the hallicrafters co.

Figure 1. Hallicrafters Model HT-41 Linear Amplifier.

ERRATA SHEET MODEL HT-41

ERRATA SHEET

SERVICE PARTS LIST

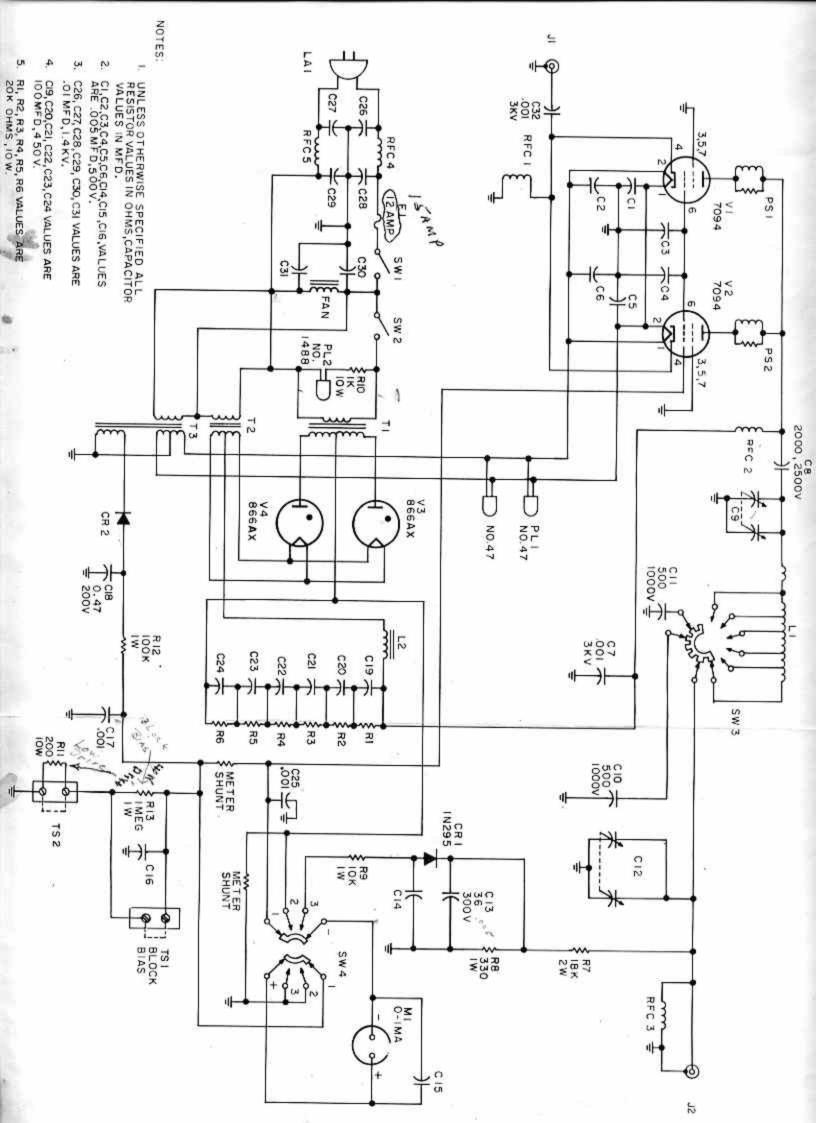
Prior to production but after the handbooks were printed certain minor electrical changes were made in the Model HT-41 Amplifier. These changes are itemized below and should be included in the handbook.

- Change fuse F1 from 12 amps to 15 amps, 250V, 3AB, slow-blow, part number 039-100441.
- The grid meter shunt, connected between R12 and the grid of V2, should be identified as R14, part number 024-001431 (400 MA, 0.250 ohms).
- The plate meter shunt, connected between the center tap of T1 and ground, should be identified as R15, part number 024-001432 (800 MA, 0.125 ohms).
- 4. Change Switch SW2 from part number 060-002276 to part number 060-002497.

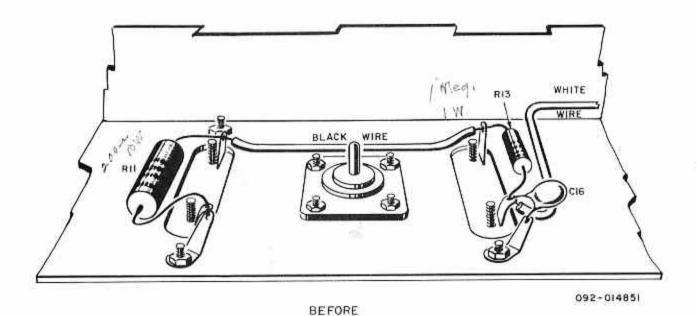
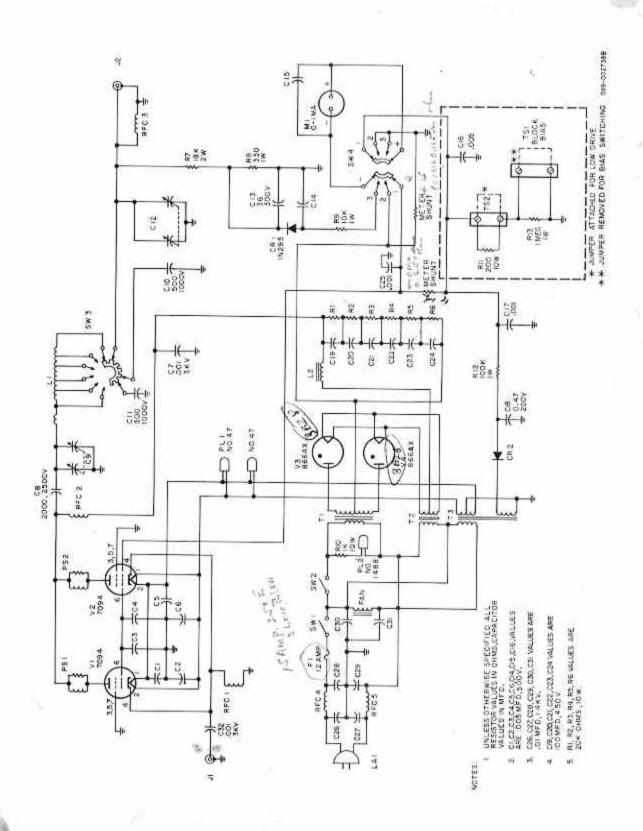
Certain minor electrical wiring modifications were made in the Model HT-41 Amplifier to assure compatibility with most available transmitter/exciter units.

Figures 1 and 2 are pictorials showing partial views of the affected areas before and after modification. The schematic diagram, figure 3, shows the affected area set off by dotted lines.
